**NUMBER:** 18-087-16

Engine Oil Viscosity Upgrade And Flash Enhancements

2016                      (WK)                      Jeep Grand Cherokee

***Fig. 1 Cap Before Sticker Applied***

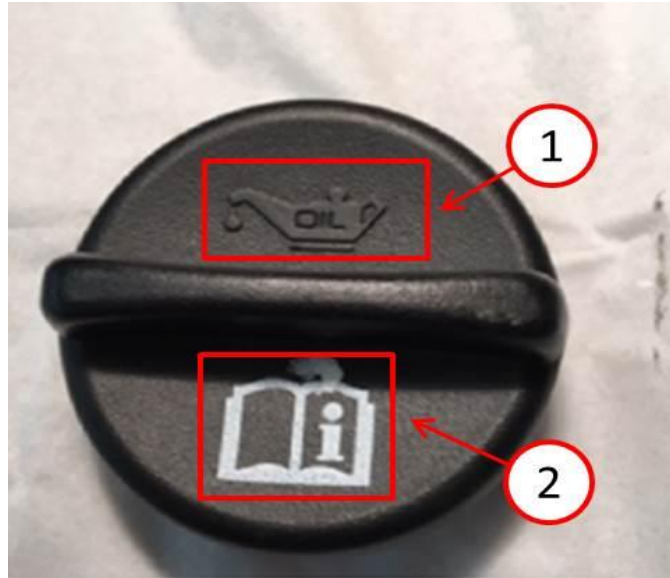
7. Clean top of oil fill cap with Isopropyl alcohol or equivalent and apply engine oil viscosity rating sticker as shown in (Fig. 1).

- 1 - Do Not Cover This Embossed International Oil Symbol
- 2 - Cover This Old Oil Info Symbol With The New "5W40" Label
